# SERVICE BULLETIN

## GROUND CONNECTION FOR PICK-UP WIRING FOR ROTAX® ENGINE TYPE 912 (SERIES) SB-912-007 UL

**Ground connection for pick-up wiring, ROTAX Engine Series Type 912**

- Subject:** Improvement of ground connection for the screening braid of pick-up wiring and charging cable
- Engines affected:** All engines of Series 912 A, beginning with engine no. 4,076.064, since introduction of the SMD-ignition unit.

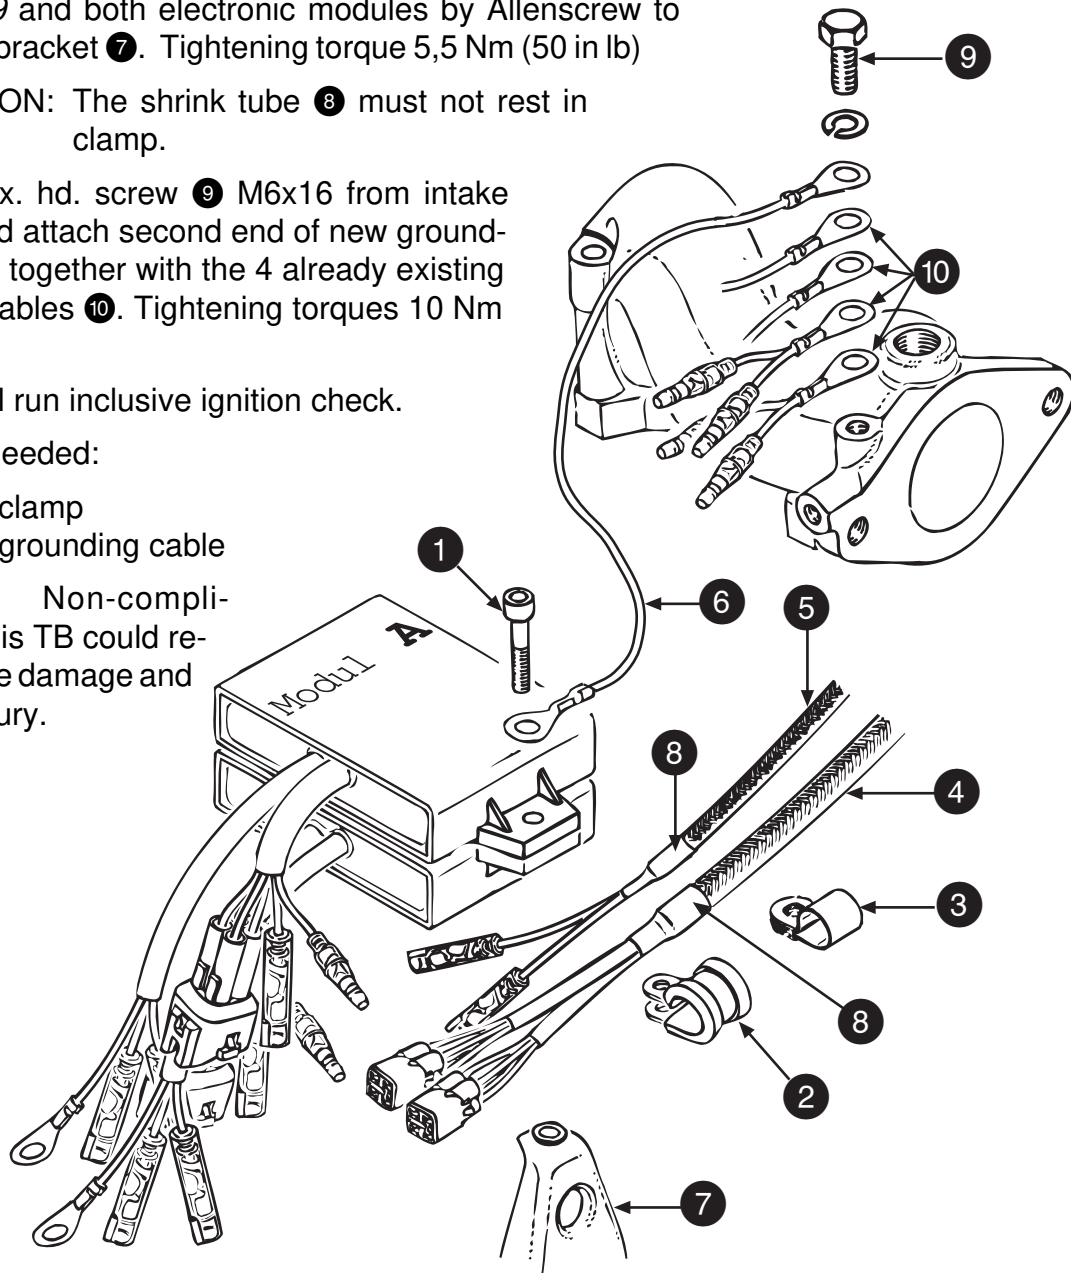
- Reason:** On the current installation of the ignition unit, troubles could occur in areas with heavy radio transmission. Because of the good result of the respective tests for EMC (electro magnetic compatibility) all the engines affected have to be reworked.

- 1) Remove Allen screw ① M5x25 and the clamp ② with rubberlined inside.
- 2) Slide new clamp ③ ( without rubberlining) over the cable-assemblies ④ and ⑤ so far that the screening braid rests completely in the clamp.
- 3) The shorting cables have to be furnished with screening over the complete length. The sceening to be attached via short connection prices on the Allen screw ① together with grounding cable ⑥. On the ignition switch side the screening of the shorting cable has to be securely connected to ground too.
- 4) Attach new grounding cable ⑥ *part-no. 965 787*, clamp ③ *part-no. 851 119* and both electronic modules by Allenscrew to ignition coil bracket ⑦. Tightening torque 5,5 Nm (50 in lb)

■ **ATTENTION:** The shrink tube ⑧ must not rest in clamp.

- 5) Remove hex. hd. screw ⑨ M6x16 from intake manifold and attach second end of new grounding cable ⑥ together with the 4 already existing grounding cables ⑩. Tightening torques 10 Nm (90 in lb)

- Compliance:** The necessary rework has to be carried out at the next 100 h check, but at the latest by 15<sup>th</sup> March 1995.
- Remedy:** Optimizing of the grounding in accordance to the instructions overleaf.

- 1x 851 119 clamp
- 1x 965 787 grounding cable
